KALIMPONG MUNICIPALITY

CONSTRUCTION SITE SECOND VISIT REPORT

Second Visit : PROP-00746 - INDUSTRIAL PARK (FIRST FLOOR)

Photo 1 - Angle 1

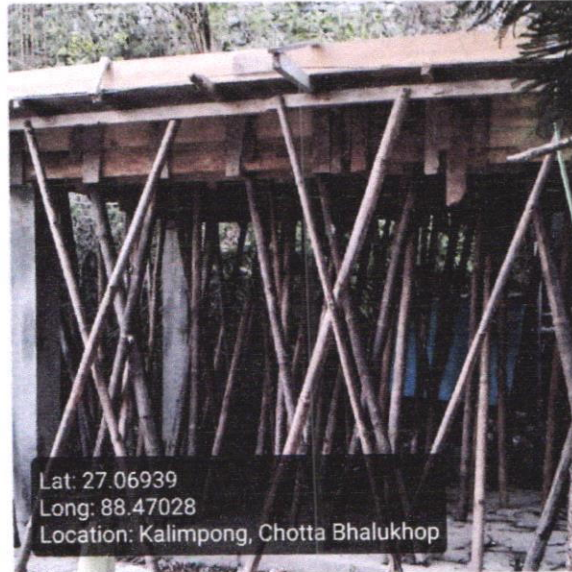
All reinforcement parameters are found to be satisfactory; however, the shuttering is not level. The ULB Engineer has been advised to ensure proper leveling of the shuttering prior to casting.
